# **New PadPlane Connector Locations for the FEE electronics cards**

**August 14<sup>th</sup>, 2015**

# Old Compared to New

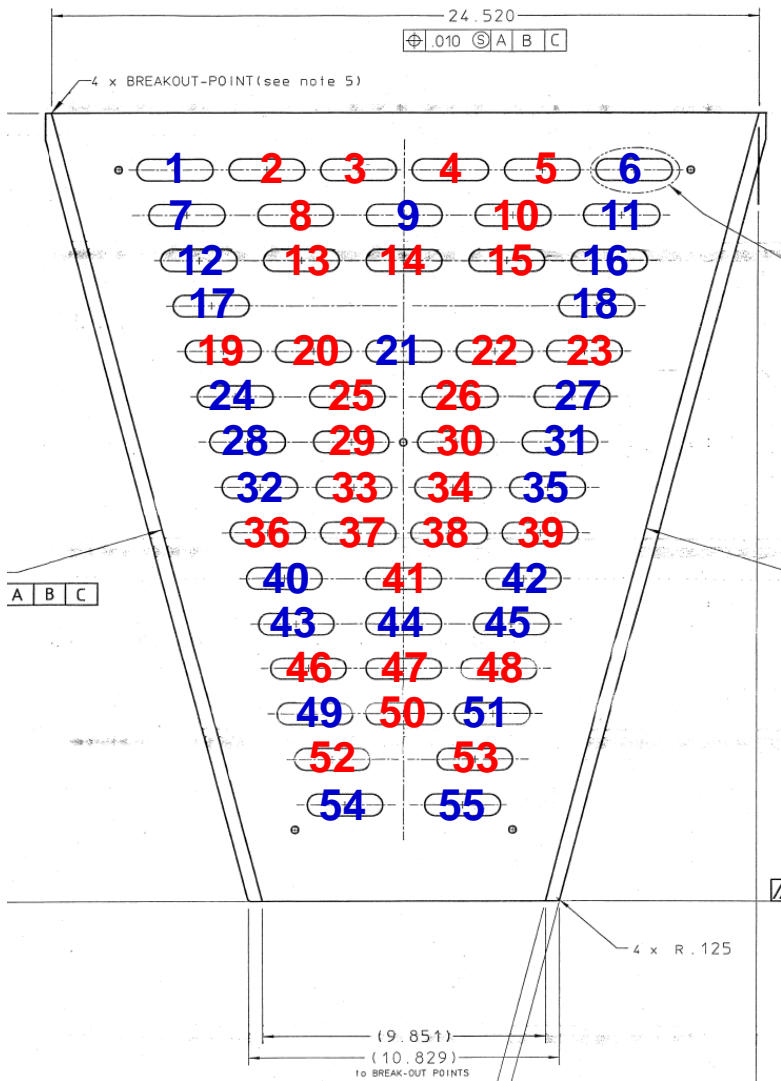
- **John Hammond and Bob Scheetz have finished laying out the new padplane**
  - **Many thanks!!**
- **Connector locations for the FEE cards are shifted, slightly, and slots are wider compared to the previous (circa 1995) locations**
- **Changes**
  - **Delete 30 locations from previous total of 55**
  - **Add 3 new locations on the centerline**
  - **New total:  $25 + 3 = 28$**
  - **Connector locations remain the same in one dimension, but in the other dimension they all move down by 0.221”**
    - **“Down” means toward the narrow end of sector**
  - **Slots are to be made wider by 0.225”**

# Shift and Widen Slots

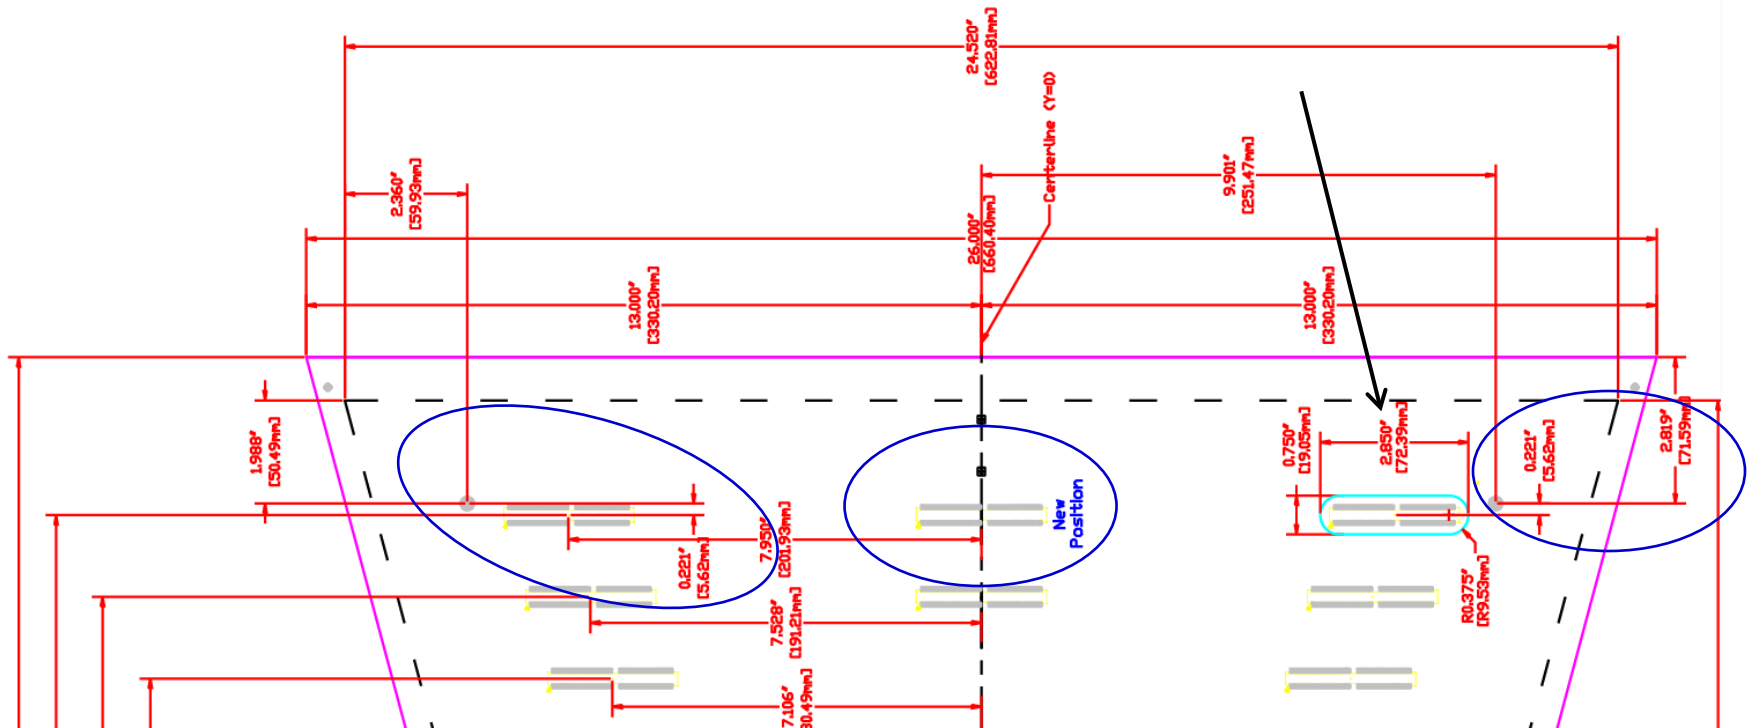
- Horizontal distance from centerline remains the same for all slots
- New slots go on the centerline (3 total)
- All slots (including new slots) are shifted down by 0.221" compared to positions and rows on drawing 24A368D (circa 1995)
- All slots (including new slots) are 0.225" wider (total width = 2.850")

# Slot Detail

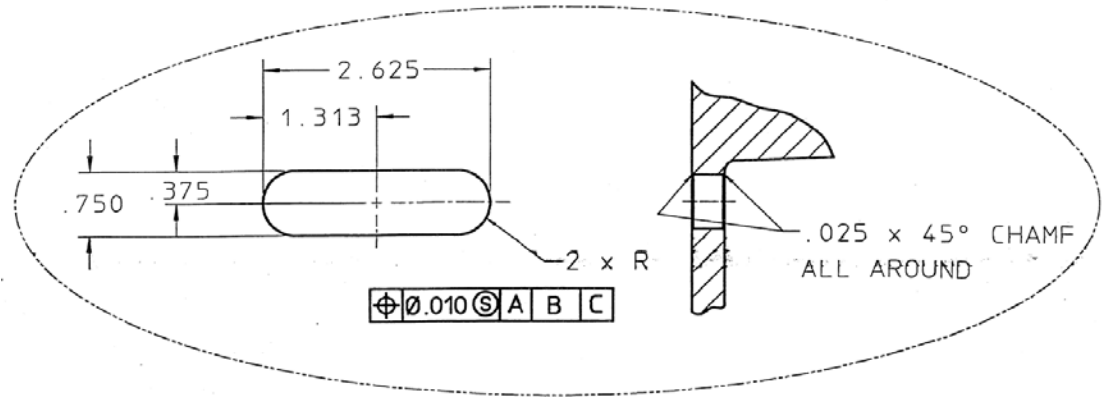
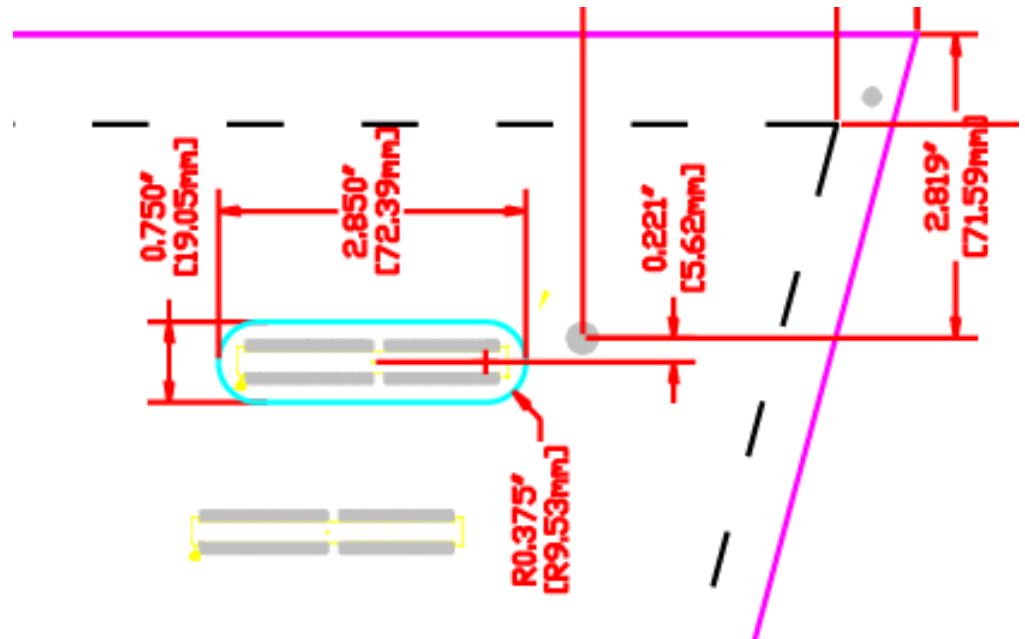
## Old Slot Detail from LBL Drawing 24A368D (circa 1995)

The connectors for the new electronics cards fit in the slots. The old cards used a right angle connector while the new cards will use a card-edge connector which is wider and necessarily shifted down slightly.

## New Slot Detail
